# King County Surface Water Design Manual Update Advisory Group Meeting

May 29<sup>th</sup>, 2014

# Proposed Changes to KCSWDM

## Enhancement #4-Roofing is PGIS

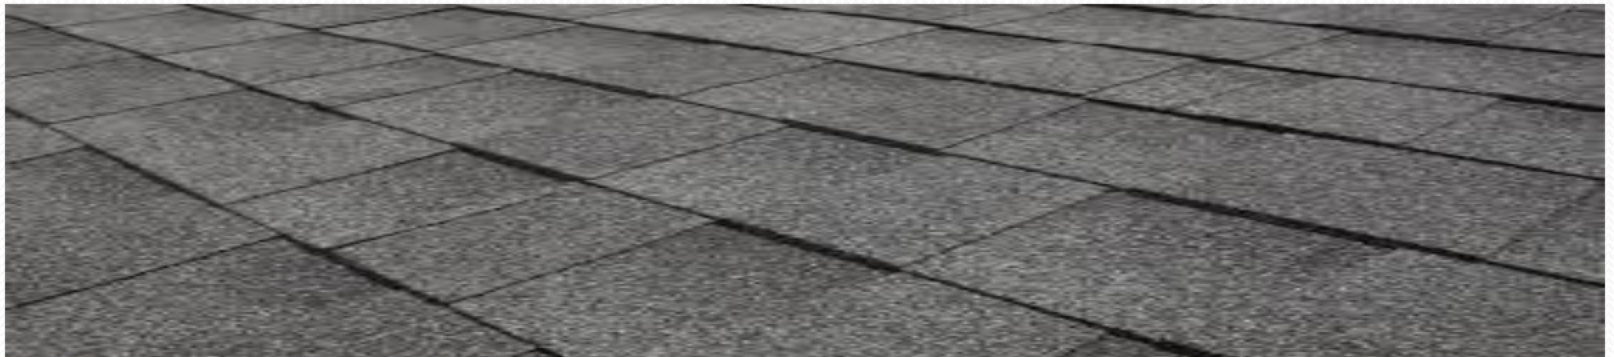
Roofing is proposed to be considered pollution generating impervious surface (PGIS) unless roofs are composed of materials listed in the KCSWDM and have covenants that restrict use of chemicals.
